**TOWN OF NEWBURGH  
PLANNING BOARD  
REVIEW COMMENTS**

**PROJECT: BRITAIN PLAZA**  
**PROJECT NO.: 13-13**  
**PROJECT LOCATION: SECTION 97, BLOCK 3, LOTS 1 & 2**  
**PROJECT REPRESENTATIVE: LANC & TULLY, PC**  
**REVIEW DATE: 10 JULY 2014**  
**MEETING DATE: 17 JULY 2014**

**COMMERCIAL SITE PLAN**

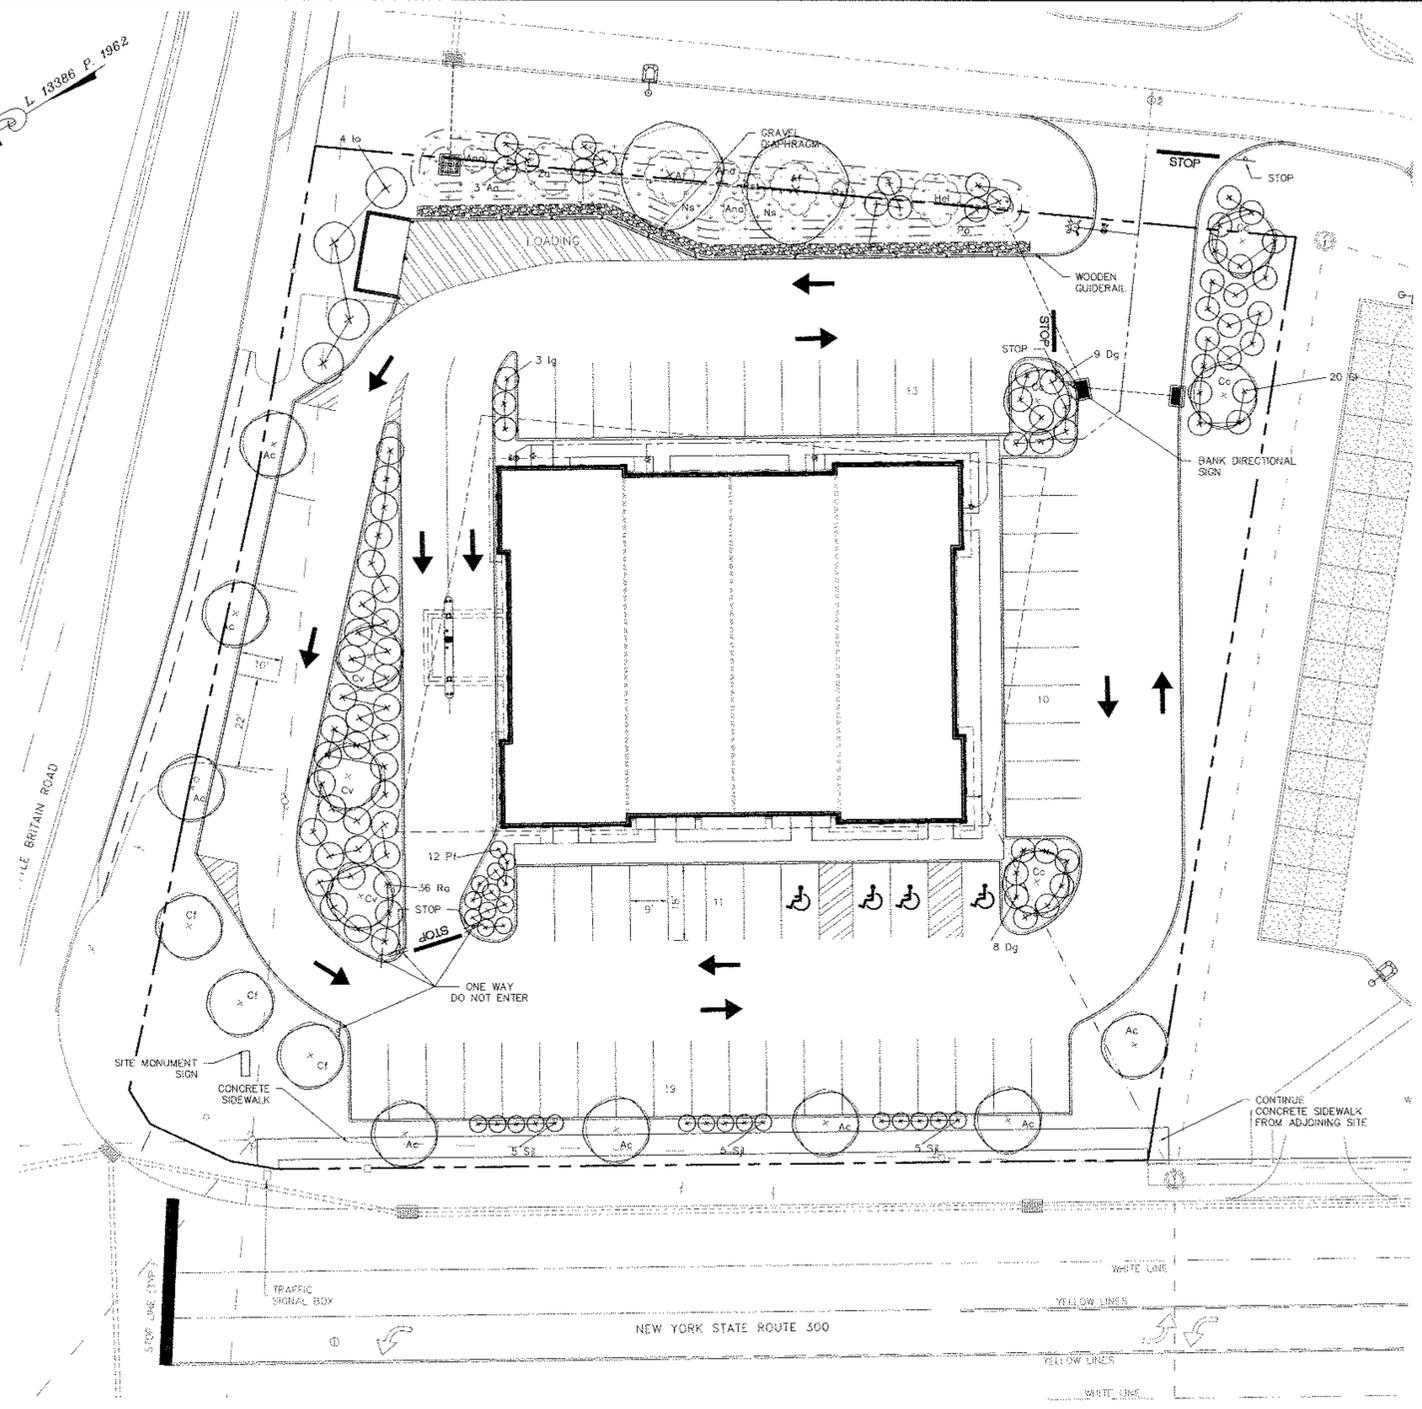
1. Information pertaining to the previous “DOT taking for right turn lane (2008)” should be addressed. If this area is a taking, the lot line should be appropriately revised.

2. Highway Superintendent’s comments on the re-grading and removal/replacement of existing shoulder should be received.
3. A sidewalk is proposed along the Union Avenue frontage which contains a jog to the east from the proposed Crystal Run sidewalk onto what appears to be the subject property. Input from NYSDOT regarding this sidewalk should be received. Sidewalk apparently terminates at a traffic signal box on the north end of the sidewalk. Handicap accessibility as well as pedestrian accessibility at this location should be evaluated.

5. The Applicants have stated the dumpster enclosure must remain at the previously identified location. Dumpster is located within front yard setback near the intersection of the project access road off of Old Little Britain Road. It appears dumpster could be relocated to the opposite side of the lot near the access drive to the project.

6. The discharge pipe at flared end section #1 requires pretreatment prior to discharge to a bio-retention treatment system.
7. The location of any proposed signage should be depicted on the site plan.

8. Comment 2 from the 5 June meeting requested compliance with design guidelines be documented. Any waivers of those should be requested including parking in front yards.
9. Site lighting should be addressed on the plans.
